Bulletin No. 18 July 2008

### **Hydrant Pit Valves and Couplers**

This bulletin is issued as an update to Bulletin 3 of February 2005 and is intended to provide guidance to Hydrant Operators and Into-plane Services regarding the implementation of API/EI 1584 Third Edition requirements first issued in 2001 and reaffirmed in 2007.

#### Carter 64800 and 64900 Couplers

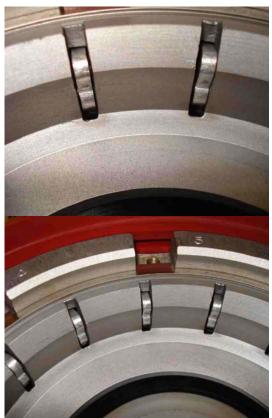
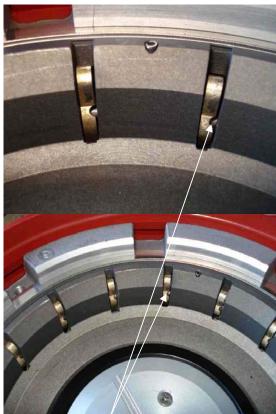
Carters now supply only third edition couplers. For these to be used at locations with second edition pit valves, the couplers need to be converted to second edition by fitting second edition lugs. Carter have authorised their distributor Warner Lewis, to

carry out the conversion of new third edition couplers to second edition prior to shipment. However, second edition needs to be specified in any orders for new equipment unless the fuelling equipment is to be used at an airport with 100% third edition compliant pit valves. Conversion to second edition may also be done on site by ordering a set of second edition lugs from Carter or their authorised distributor. The third edition lugs shall be replaced when the pit valves are 100% third edition compliant.

The Carter third edition lug has a groove machined into it and can be readily identified as shown below:

Old Second edition style lugs

New Third edition style lugs with machined breakaway groove
